AL/11/24/OUT – Response to WSCC Comments dated 24/04/26

DATE:	31 March 2026	CONFIDENTIALITY:	Public
SUBJECT:	AL/11/24/OUT – Response to WSCC Comments dated 24/03/26		
PROJECT:	Land at Westergate	AUTHOR:	Philip Moss
CHECKED:	Chris Williams	APPROVED:	Andrew Blacker

This Technical Note has been prepared by WSP to provide a response to the Highways comments provided by West Sussex County Council (WSCC) on the 24 March 2026 in their role as the Local Highway Authority. This document provides a summary of the comments raised by WSCC with the WSP response provided below.

Figure 1 – 2031 Do-Something AM Peak Traffic Flows

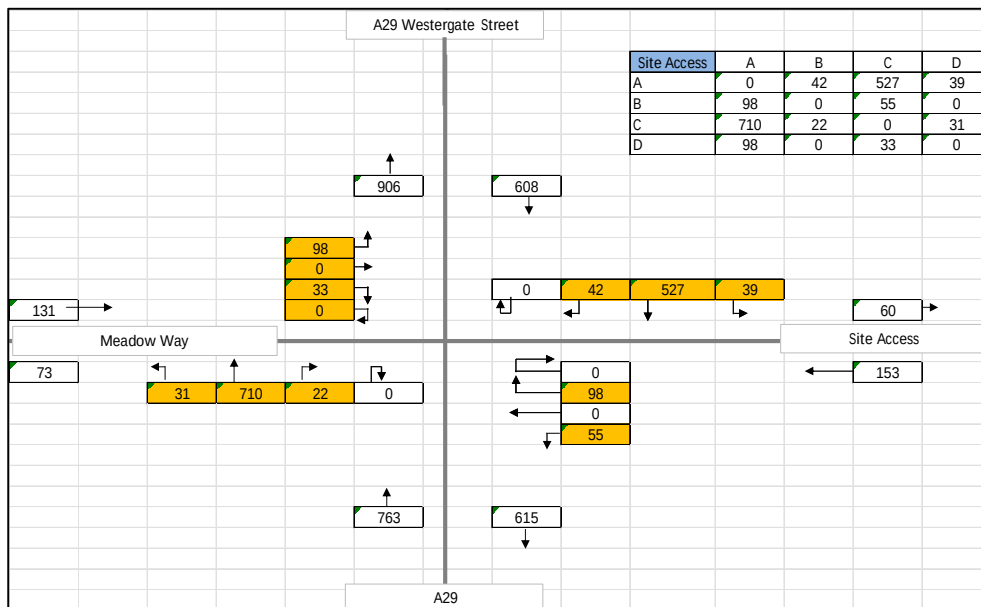
Modelling – Please provide additional information on the turning flows used within the level crossing assessments completed to-date. Please also confirm if there an opportunity to provide an additional exit lane on the site access if additional land (third party or other) were to be used?

The traffic flows using these scenarios are presented in Figure 1 and 2 for the AM and PM peak hours respectively.

These traffic flows were used in LinSig assessments and the calculation of queue lengths associated with closure of the Woodgate level crossing, as described below.

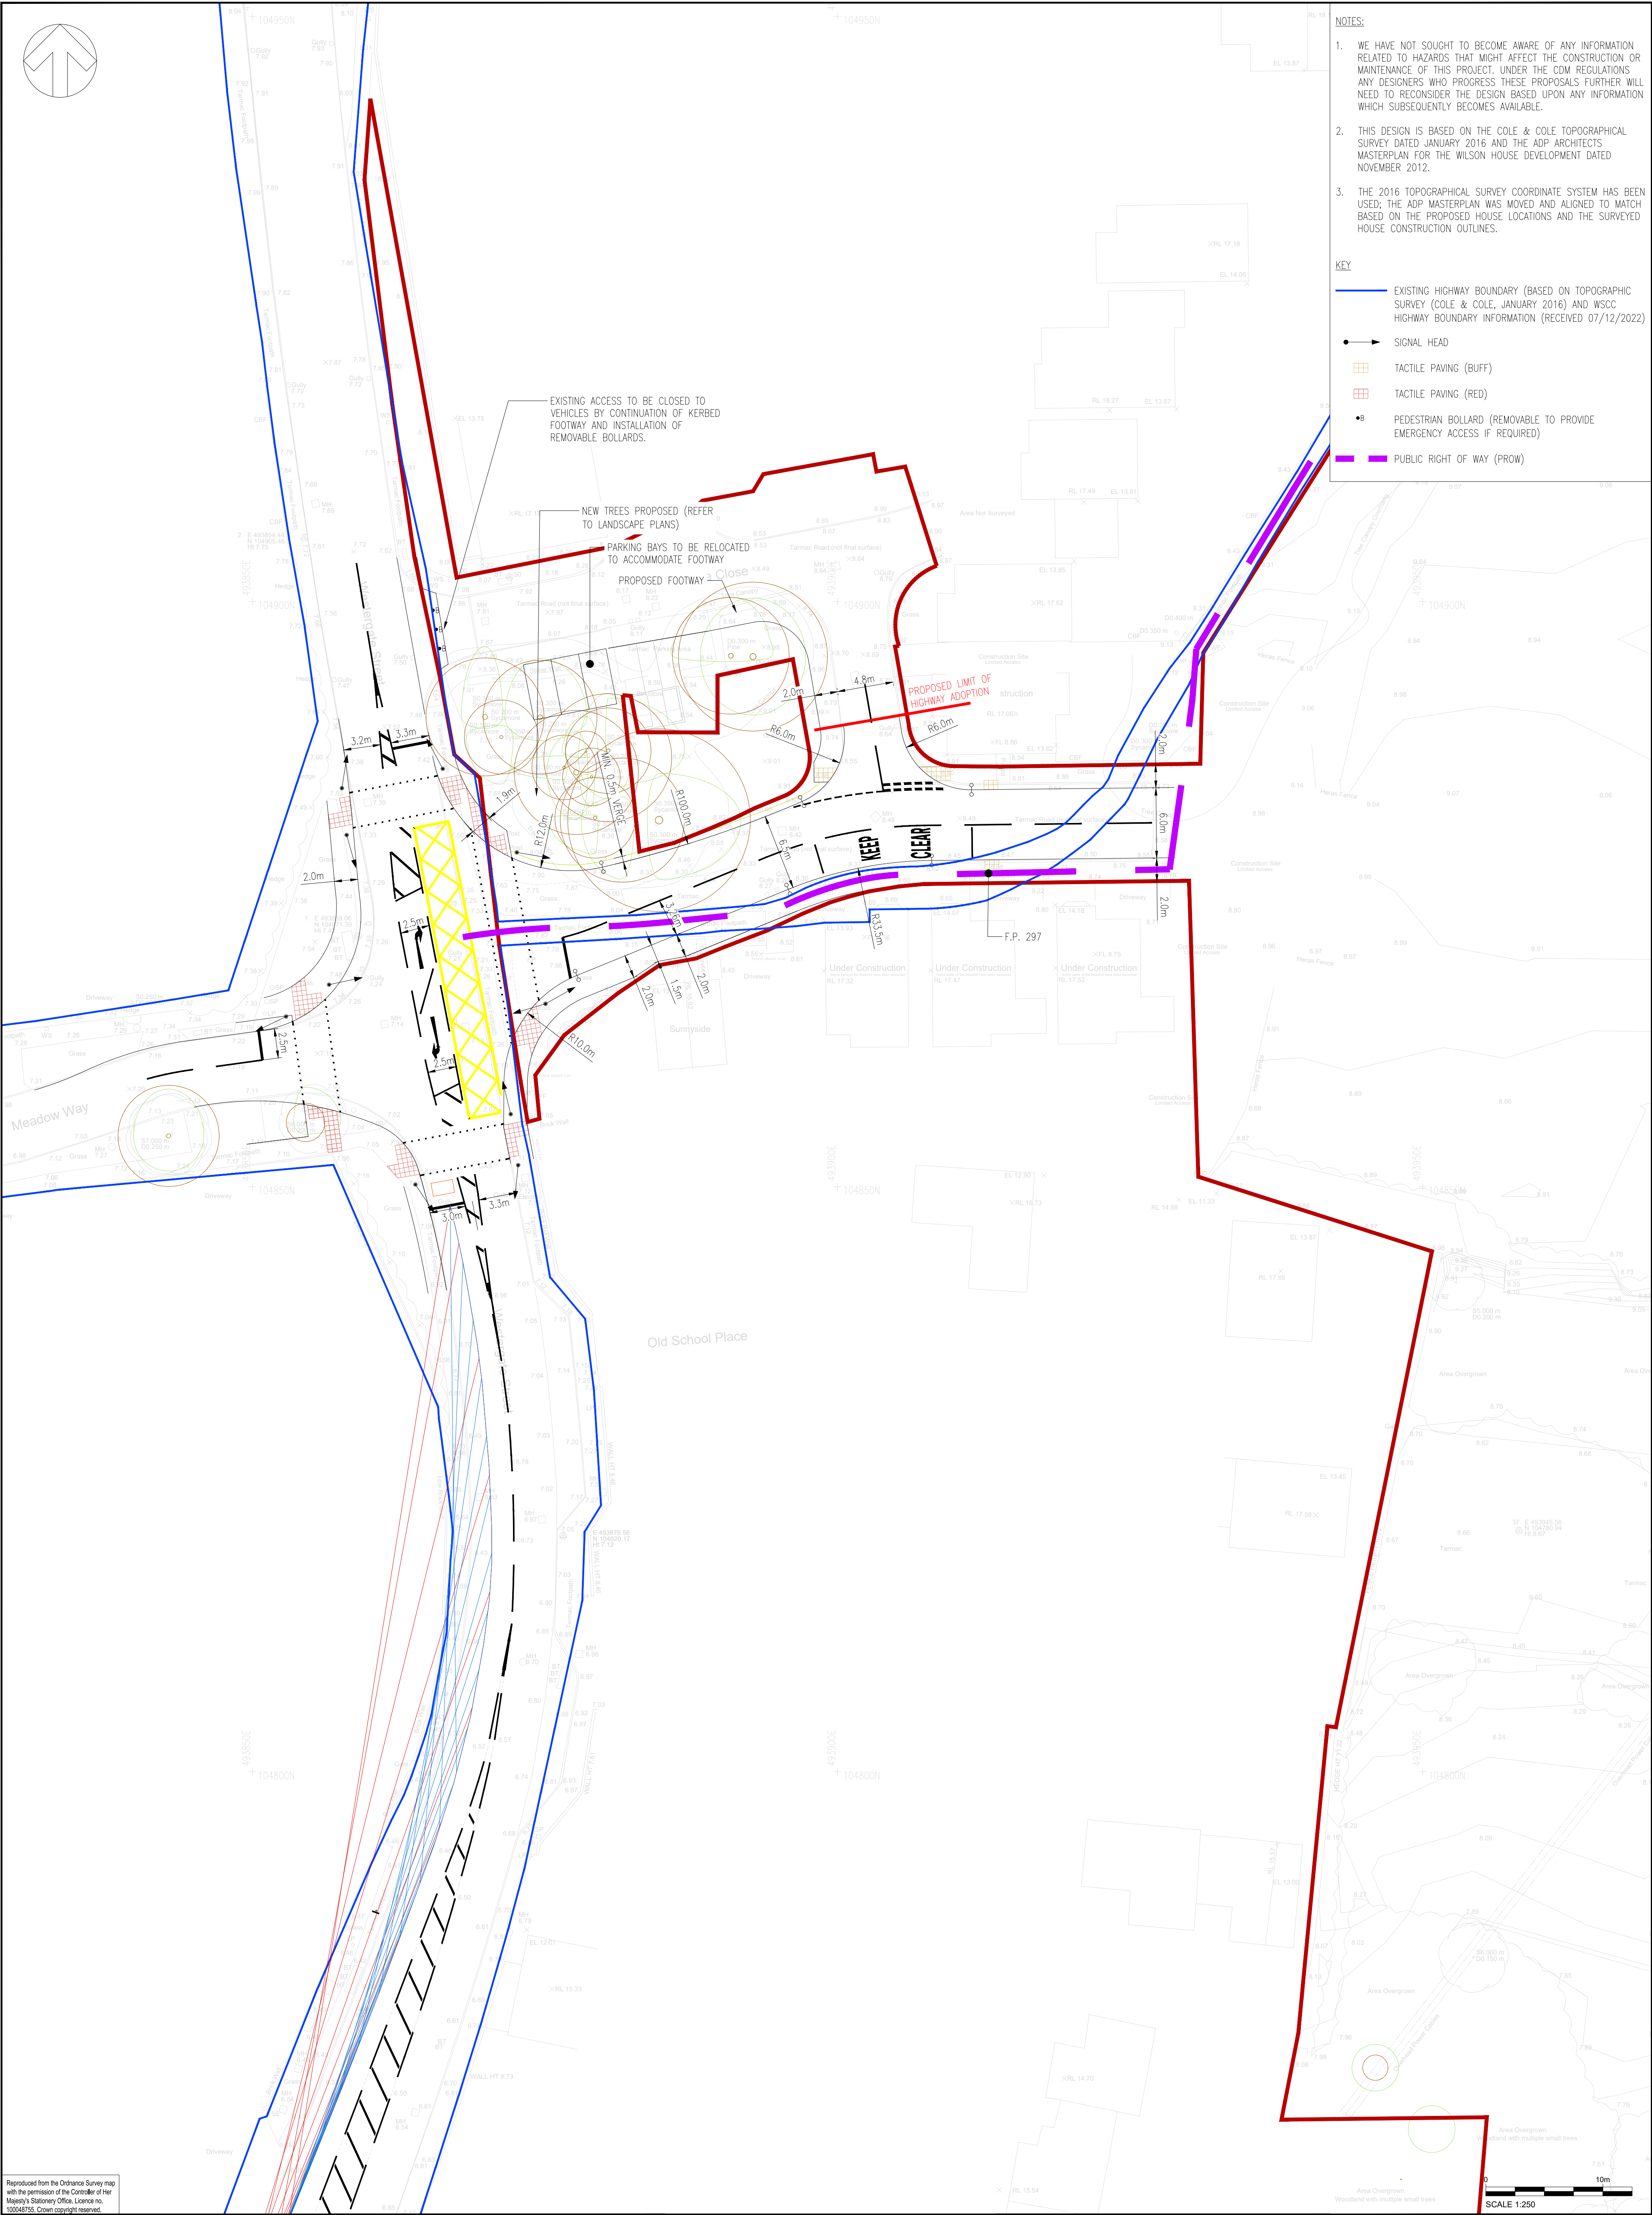
Closure of Pine Close – Engineering detail of closure required. Please can a solution for this be considered in more detail.

Drawings LAW-WSP-ZZ-ZZ-C-DR-00006 (Site Access General Arrangement) and LAW-WSP-ZZ-ZZ-C-DR-00007 (East West Link Road General Arrangement) have been updated to provide revised proposals for the closure of Pine Close as shown in Figure 4. This allows for a continuous footway along Westergate Street.

SCALE @ A1: 1:500	CHECKED: JB	APPROVED: LRB
PROJECT No: 70013258	DESIGNED: GLG	DRAWN: GLG
DATE: September 23		REV: P04
LAW-WSP-ZZ-ZZ-C-DR-00007		
© WSP UK Ltd

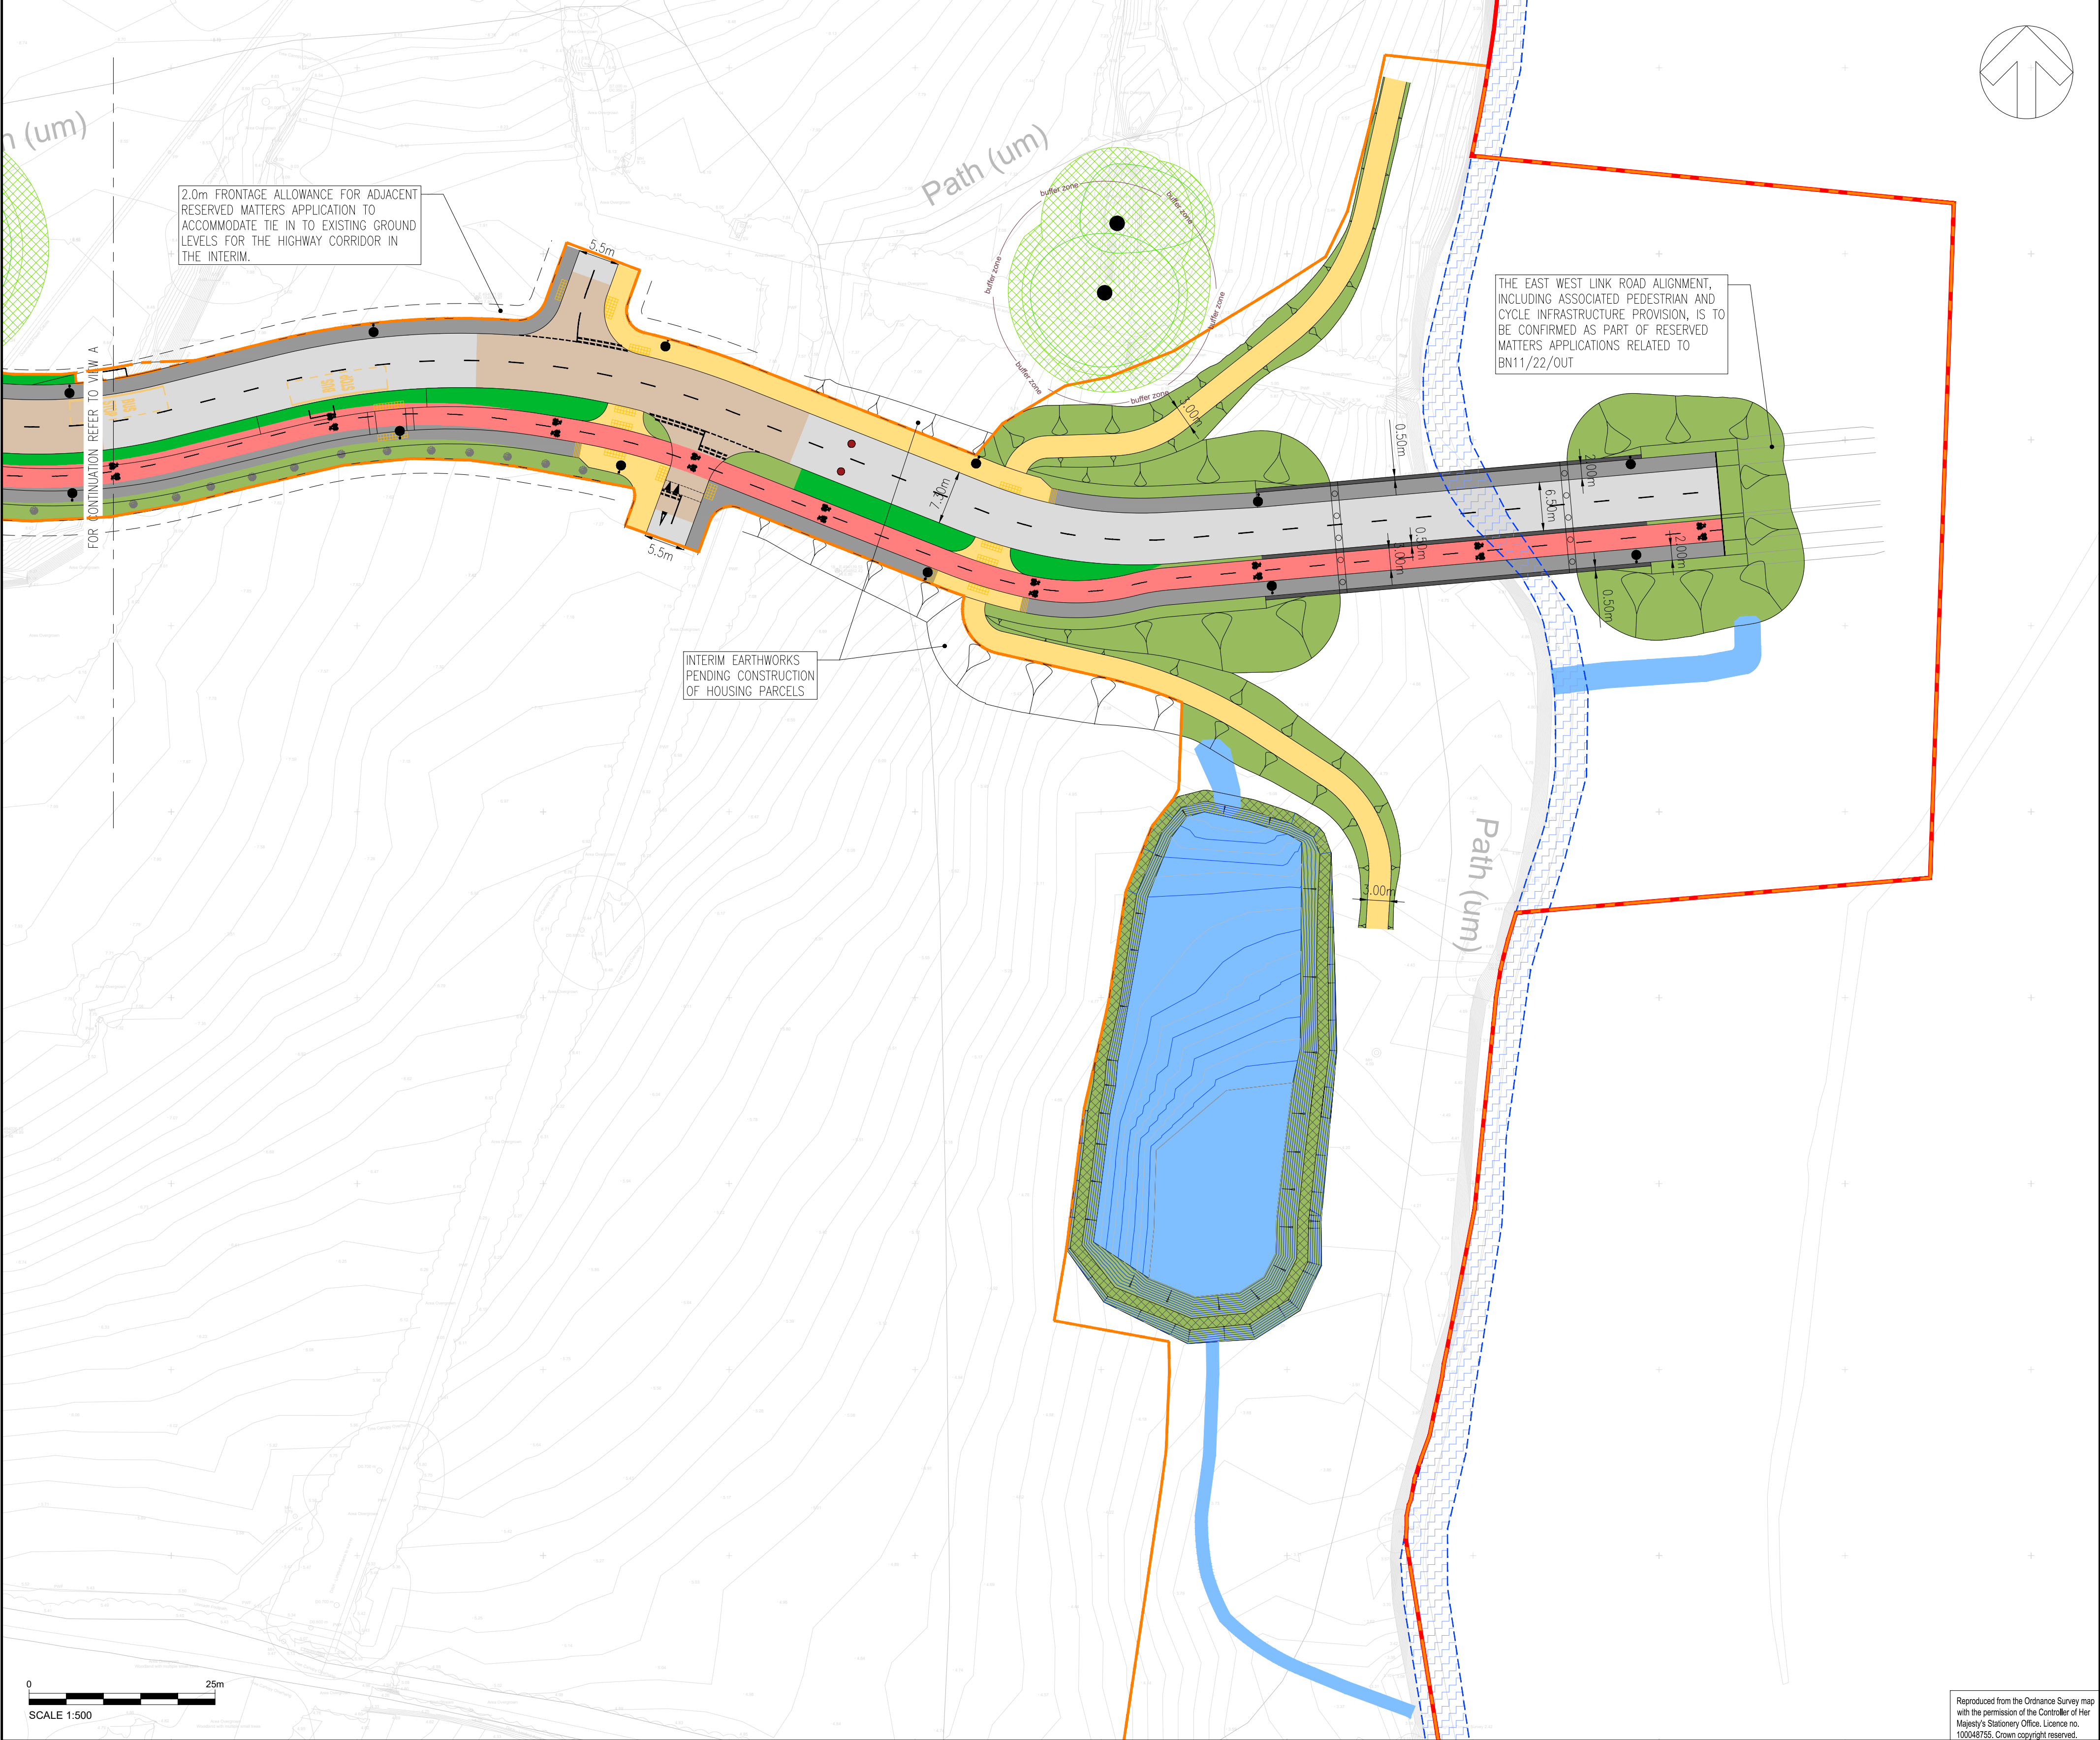
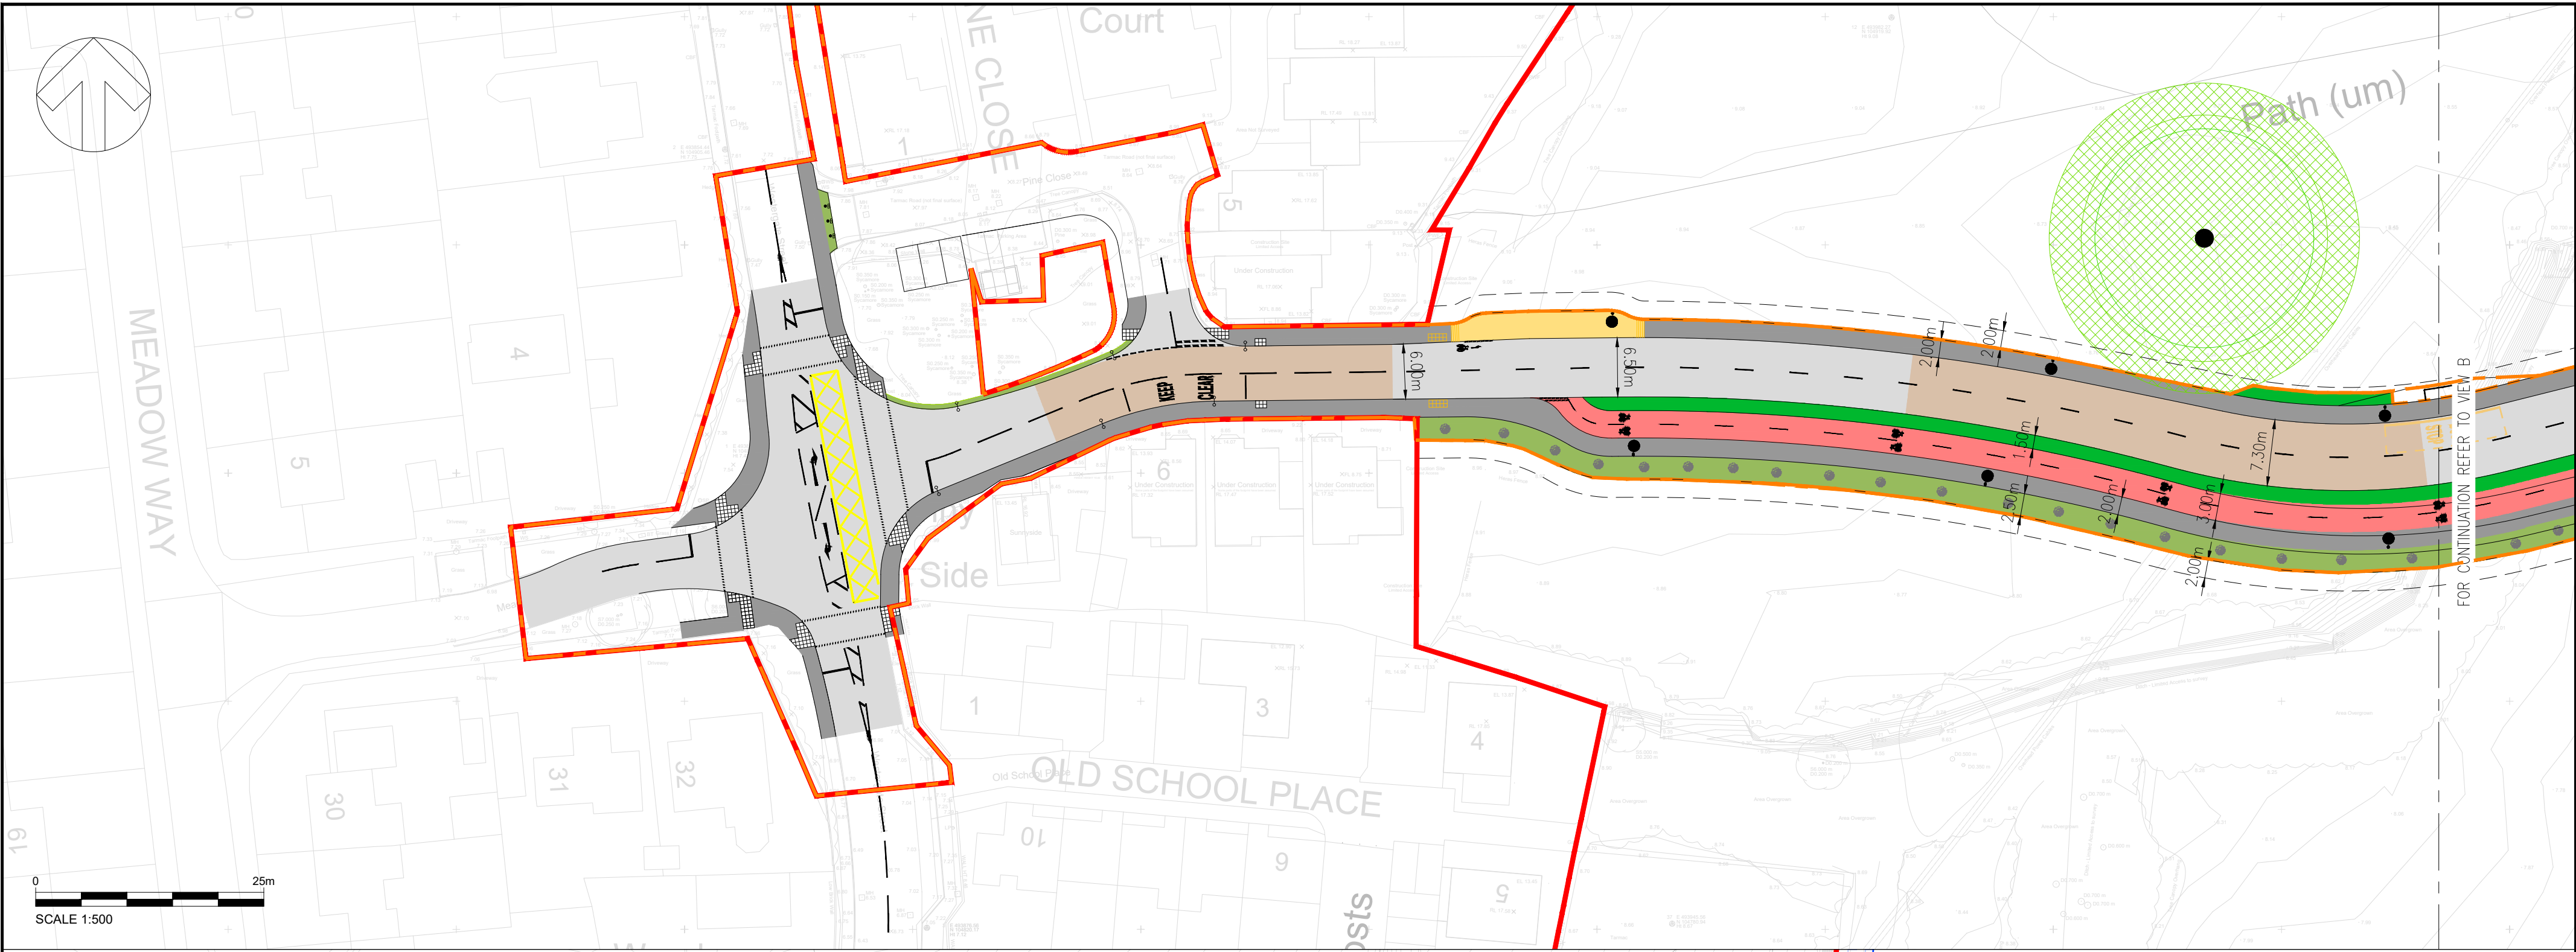
Foot and cycle infrastructure on bridge forming part of E-W link – Please add a note on relevant drawings to state that details of the E-W link east of the bridge are to be confirmed as part of reserved matters applications for the Church Commissioner's land. Also, please demonstrate that the proposed pedestrian / cycle infrastructure meet the requirements of LTN 1/20 with regard to dimensions, including kerb and verge spacings to/from the carriageway and 'scare' distance from parapet and 'live' traffic etc.

As requested an additional note has been added to WSP Drawings LAW-WSP-ZZ-ZZ-C-DR-00007 included in Appendix A which states that "the East West Link Road alignment, including associated pedestrian and cycle infrastructure provision, is to be confirmed as part of Reserved Matters applications related to BN11/22/OUT".

It can also be confirmed that the proposed pedestrian and cycle infrastructure shown on WSP drawing LAW-WSP-ZZ-ZZ-C-DR-00007 are aligned with LTN1/20 design standards through provision of the following:

- A 3m wide fully segregated bidirectional cycle route, which is in accordance with the desirable minimum width for cycle flows of up to 300 cyclists per hour as shown in Table 5-2 of LTN1/20.
- A 1.5m segregated verge along the East-West Link Road, reducing to 0.5m over the bridge. This in accordance with the desirable minimum horizontal separation between the carriageway and cycle track for a 30mph speed limit, as shown in Table 6-1 of LTN1/20.
- Provision of low / splayed kerbs between the cycle track, footway and buffer zone meaning that no additional width is required for the cycle track.
- Priority is maintained for cyclists at the southern side-road access of the masterplan, with vehicles required to give-way to cyclists using the bidirectional cycle track.
